# Supporting Documentation Prestbury St Peter – Stained glass

Replacement of the existing plain glass in the Oriel window in St Peter's Rooms with a stain-glass pane

Ref:	2021-062062	Church:	Prestbury: St Peter
Diocese:	Chester	Archdeaconry:	Macclesfield
Created By:	Mr Steve Hill (24/05/2021)	Contact Tel.:	07768757593
Status:	Pre-formal consultation review

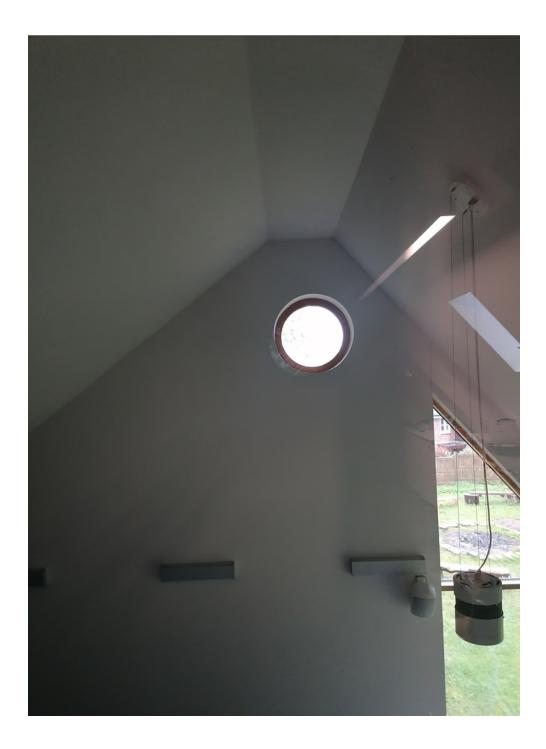
c. The Committee considered that currently the image of the dove does not really give a sense of movement (for example evoking a soaring spirit). It therefore wondered whether other ways of depicting the dove could explored, for example with it ascending or descending, or alternatively flying horizontally with wings outstretched left and right.	
	<ul> <li>It also felt that currently the border around the edge of the image would be noticed more than the dove and it would benefit from the image being made simpler</li> </ul>

e. It was noted that the window is east facing and therefore the light from it will have a big impact on interior of the extension, so the use of brighter, more vibrant colours was encouraged

f. Likewise the use of brighter, more vibrant colours would improve the impact of the window in the space, with it being small and positioned high up in the extension	
05/07/2021	Lots of ideas there to work on.	
To: Katy Purvis From: Steve Hill		
15/10/2021	I submitted revised proposals for the above yesterday and, as I am away from tomorrow for 10 days, I just wanted to be sure it was safely	
To: Katy Purvis From: Steve Hill	submitted and that it constitutes the full faculty application. If not, please let me know asap.	
21/10/2021	Sorry for the delayed reply, we have been terribly busy getting	
	prepared for tomorrows meeting. You missed the deadline for that,	
To: Steve Hill	but the agenda is so full, I really couldn't fit this in so I have put it on	
From: Katy Purvis	for November. It all looks fine as far as I can see	
12/11/2021	We have heard back from the stained glass advisor as follows, she has a few comments/questions as below

From: Katy Purvis	My initial impression of the new design is that the disjointed outline and partial colouration of the dove is less clear than in the original & it might be hard to see what it represents from the ground. However if the family wish to create a general impression of coloured light rather than a distinct dove I see no reason to object, especially as they were told that the original more conventionally-shaped dove looked rather wooden. Since the window is in the new annexe, its design needn't be constrained by the style of the historic church building. I have a couple of questions: Which stained-glass artist/firm will execute the commission, or is that yet to be decided? Will the panel contain an unobtrusive date & signature or inscription naming the maker? Since there's no point in including an inscription in the window given its high position, will a plaque be placed beneath it?

Following receipt of the DAC's informal advice, the design has now been modified and finalised. The dove symbolises two things in people's minds – the Holy Spirit primarily, but also a symbol of peace. It flies upwards, encouraging us to aspire, to let go of whatever stops us being who God created us to be. The burst of colour around it suggests the joy of freedom in Christ. If people only experience it as a mark of peace, then so be it. Peace is full of joy.

There is now no "border" round it, the dove is ascending and the colours are more vibrant. We feel therefore that the revised design meets our (and the DAC's) aspiration for a sense of movement in the dove, and the vibrant colours bring the image to life.
